International Isotopes Inc.

Subject: Request to Amend NR-1235-S-102-S.

International Isotopes Inc. requests to amend Registry of Sealed Sources and Devices Safety Evaluation of Sealed Source number NR-1235-S-102-S to include new models; BM06V-5 series, BM06V-10 series and BM06V-20 series. The Models BM06V-5, 10 and 20 represent 5 cc, 10 cc and 20 cc serum vials and are intended to be utilized with pressurized ion chamber dose calibrators. Maximum and nominal activities and available radionuclides are the same as the Models BM06S and BM06E series source geometries currently registered in NR-1235-S-102-S.

The following revisions, noted in **Bold**, to NR-1235-S-102-S are requested:

Model BM06V 5cc, 10cc, 20cc Vials

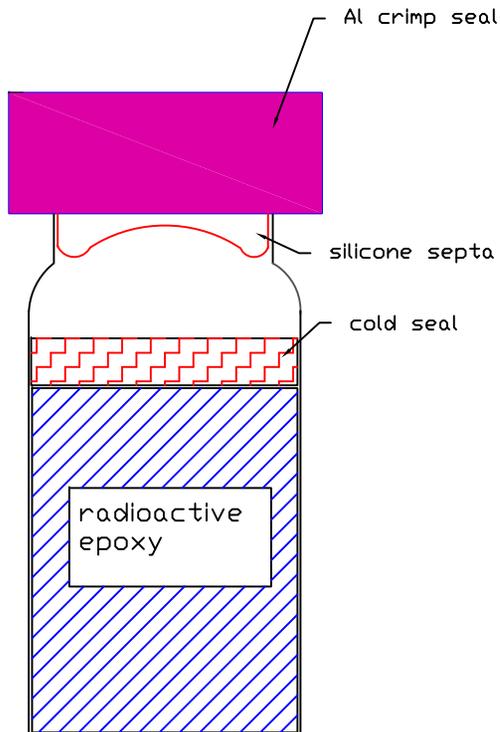
The Model BM06 Series sealed sources are intended for use as reference standards to check the response of dose calibrators used to measure research, diagnostic, and therapeutic radiopharmaceuticals. The BM06 Series offers these reference standards in ~~two~~ **five** differing geometries. The first of these is the 30 ml vial geometry referred to as the BM06E. The second geometry is the 5 cc syringe geometry referred to as the BM06S. **Geometries 3, 4 and 5 simulate 5 cc, 10 cc and 20 cc serum vials and are referred to as the BM06V5, BM06V10 and BM06V20 respectively. Both the BM06E and BM06S Series** All of these source geometries consist of a radioisotope in a chloride or nitrate complex uniformly dispersed in high impact epoxy casting resin (Emerson & Cuming Stycast 1264 or equivalent) color coded to visually differentiate the radioisotopes, which is then cured in either a 30 ml dose calibrator vial (**BM06E**), ~~or~~ a facsimile of a 5 cc syringe (**BM06S**), **or in 5 cc, 10 cc or 20 cc serum vials (BM06V5, BM06V10, BM06V20 respectively).**

The BM06V geometries consists of break-resistant plastic, type PETG (glycol-modified polyethylene terephthalate) with a 20 mm septum cap and aluminum crimp seal. The body is filled with a layer of epoxy containing dispersed radioactivity which is sealed beneath a layer of epoxy containing no radioactive material. The septum cap is set in place and then crimped onto the vial with an aluminum crimp top. The non-radioactive epoxy layer provides a barrier to the radioactive epoxy matrix should the end user remove the crimp top and septum. Access to the radioactive epoxy matrix is not possible without destruction of the vial.

Revise attachments to include Model BM06V 5 cc, 10 cc, 20 cc Vials as Attachment 4

STANDARD MODEL TABLE				
MODEL NO.	NUCLIDE	MAXIMUM ACTIVITY	COLOR CODE	GOMETRY
BM06V5-22	Na-22	0.50 MCI	YELLOW	5CC VIAL
BM06V10-22	Na-22	0.50 MCI	YELLOW	10CC VIAL
BM06V20-22	Na-22	0.50 MCI	YELLOW	20CC VIAL
BM06V5-60	Co-60	0.10 MCI	BLUE	5CC VIAL
BM06V10-60	Co-60	0.10 MCI	BLUE	10CC VIAL
BM06V20-60	Co-60	0.10 MCI	BLUE	20CC VIAL
BM06V5-57	Co-57	15.0 MCI	RED	5CC VIAL
BM06V10-57	Co-57	15.0 MCI	RED	10CC VIAL
BM06V20-57	Co-57	15.0 MCI	RED	20CC VIAL
BM06V5-37	Cs-137	0.50 MCI	GREEN	5CC VIAL
BM06V10-37	Cs-137	0.50 MCI	GREEN	10CC VIAL
BM06V20-37	Cs-137	0.50 MCI	GREEN	20CC VIAL
BM06V5-33	Ba-133	0.50 MCI	BLK/GRY	5CC VIAL
BM06V10-33	Ba-133	0.50 MCI	BLK/GRY	10CC VIAL
BM06V20-33	Ba-133	0.50 MCI	BLK/GRY	20CC VIAL
BM06V5-68	Ge-68	1.20 MCI	PURPLE	5CC VIAL
BM06V10-68	Ge-68	1.20 MCI	PURPLE	10CC VIAL
BM06V20-68	Ge-68	1.20 MCI	PURPLE	20CC VIAL

MODEL DIMENSIONAL TABLE			
MODEL	VOLUME	NOMINAL HEIGHT ⁽¹⁾	NOMINAL DIAMETER
BM06V5-	5 cc	39.5mm	22.3mm
BM06V10-	10 cc	50.0mm	23.6mm
BM06V20-	20 cc	58.1mm	29.6mm

NOTE 1: HEIGHT DIMENSION IS VIAL ONLY AND DOES NOT INCLUDE SEPTA OR CRIMP SEAL
